SUNDRY NOTICES AND REPORTS ON WELLS

Cactus Queen Unit #04

CONDITIONS OF APPROVAL

Yates Drilling Company
Cactus Queen Unit #4
Unit O, Section 27-12S-31E
Chaves County, NM
30-005-20993
Sundry attachment
April 8, 2009

CACTUS QUEEN UNIT #4

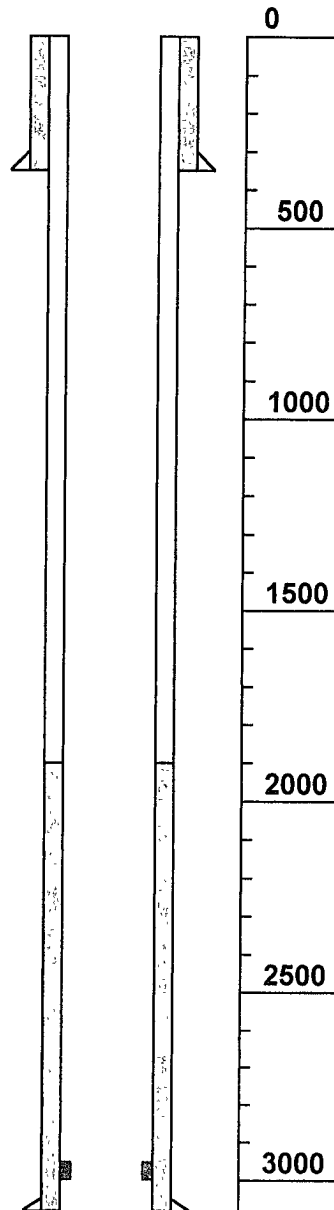
1. Set CIBP @ 2,940', mix and circulate 10# mud inside 5 1/2" casing
- ~~2. Spot 25 sxs Class "C" cement plug on top of CIBP~~
- ~~3. Perforate 2 holes in 5 1/2" casing @ 1,420', top of salt~~
4. Set packer @ 1,380' and establish pump in rate with 10# mud and circulate to surface in 5 1/2" annulus
5. Set cement retainer @ 1,380'. Mix and pump Class "C" cement to surface out 5 1/2" annulus *+ 5 sxs. cement on top of CIBP.*
6. Pump cement plug in 5 1/2" casing from 480' to surface
7. Erect dry hole marker, remove all equipment and clean location

** Spot 25 sxs. cement @ 2150', BOS.*
